TECHNICAL BULLETIN

MODEL/DERIVATIVE:
Freelander

Bulletin N°: 0017
CDS. ref: L8627bu
Issue: 1
Date: 25.04.01

HILL DESCENT CONTROL (HDC) INOPERATIVE

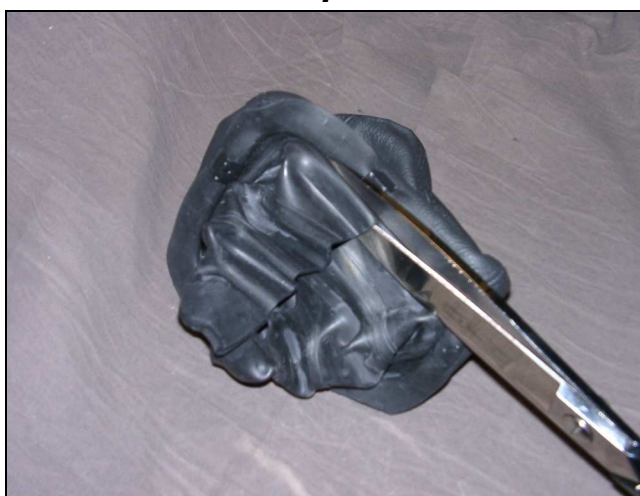
NOTE: Freelander Millennium (Double M) Limited Editions have a leather gear lever outer gaiter which is attached to the base of the original rubber gaiter. The upper section of the rubber gaiter should have been cut away when the leather gaiter was fitted.

Where a leather gaiter is fitted, examine the interior of the gaiter for a complete rubber gaiter. Illustration 1 shows a complete rubber gaiter which has been pulled out of the leather gaiter so that it can be cut away.

Cut the rubber gaiter as shown in illustration 1, leaving only the rubber base as shown in illustration 2, for securing to the console.
